ADDENDUM 2 – JOB 3

TO: All prospective bidders on project SU-1-094(170)919, Job No. 3, scheduled for the December 16, 2015 bid opening.

ADDENDUM 2
Job No. 3

Revisions for SU-1-094(170)919:

Lighting Quantities
Memorial Highway Signalization
Mandan, ND

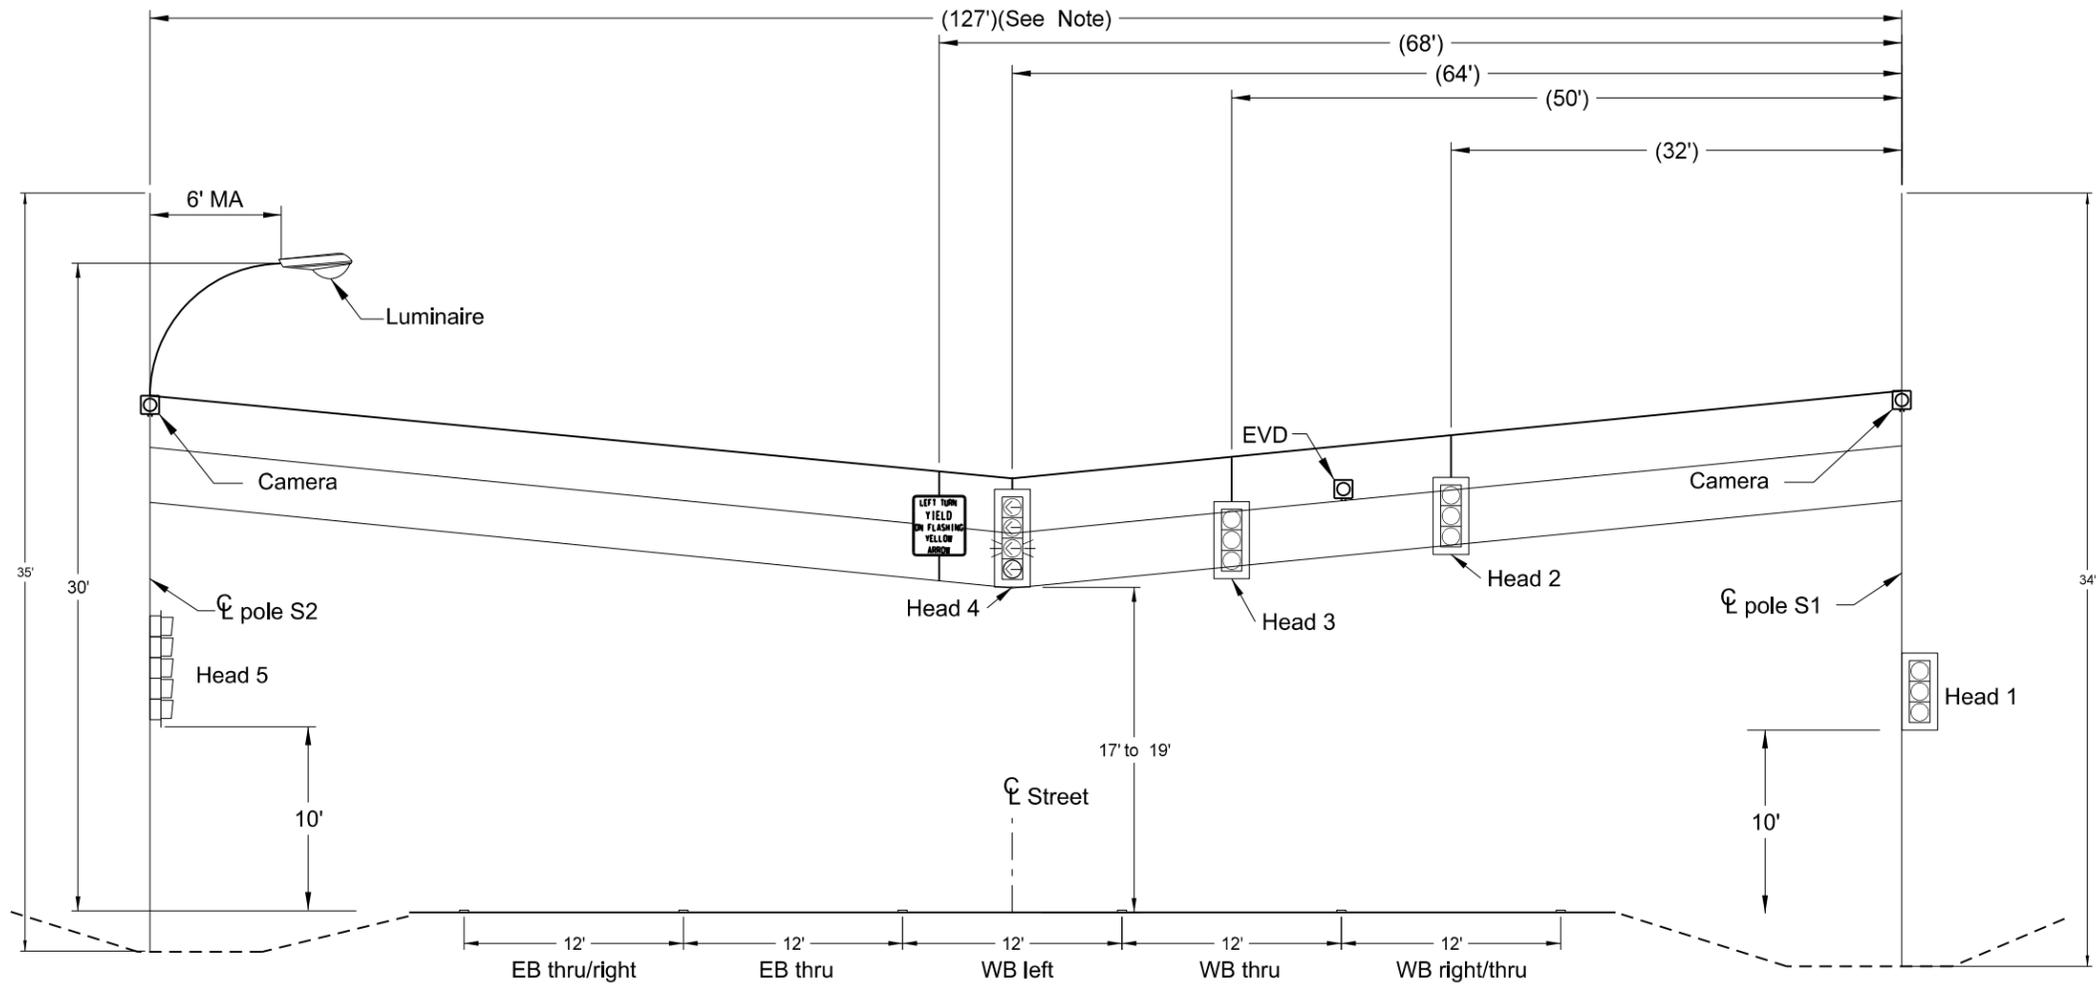
Section 140

Sheet 3:

- Revised light pole designation to luminaire extension

Traffic Signal Profiles
 40th Ave Intersection
 Memorial Highway Signalization
 Mandan, ND

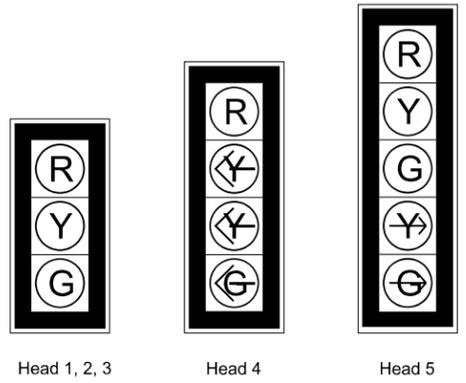
Section 150

Sheet 3:

- Removed luminaire on signal pole S1

Traffic Signal Profiles
 40th Ave Intersection
 Memorial Highway Signalization
 Mandan, ND

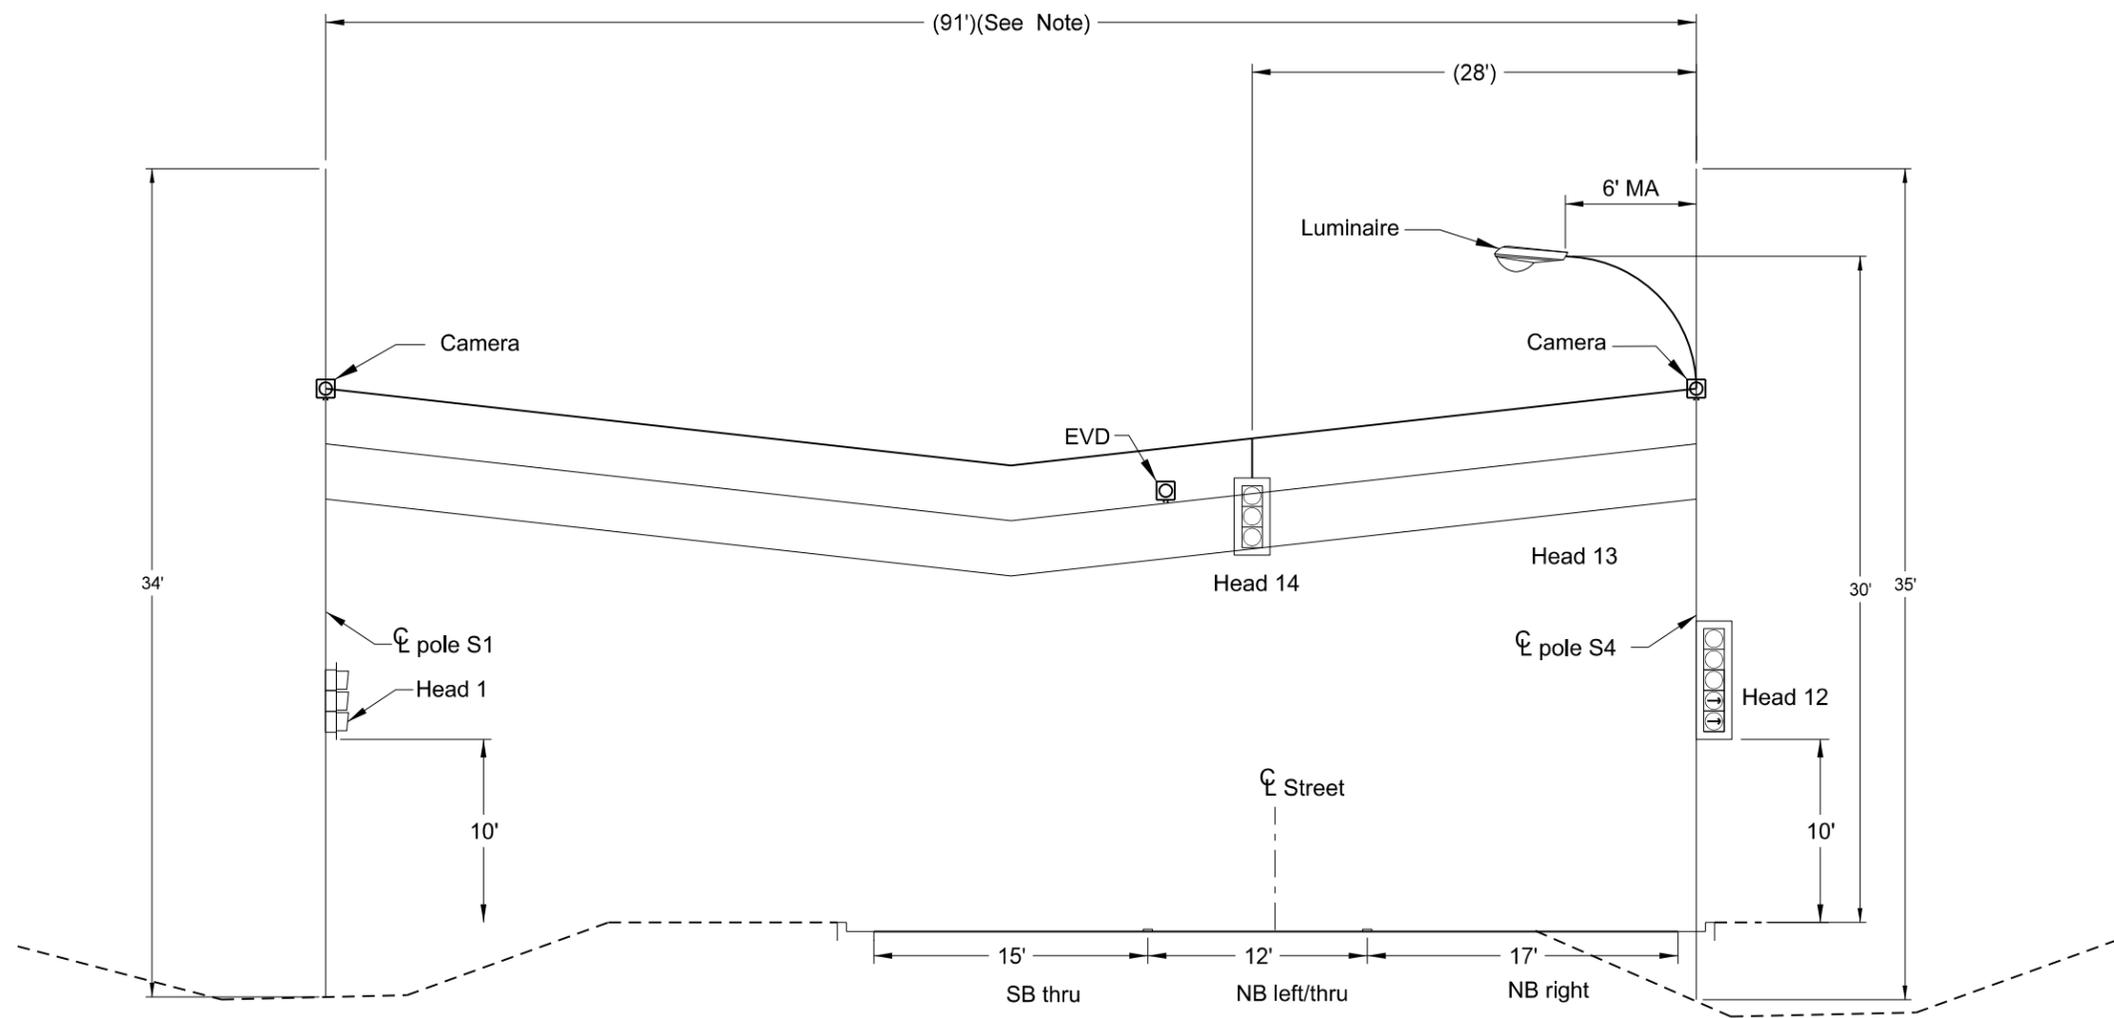
Sheet 6:

- Removed luminaire on signal pole S1
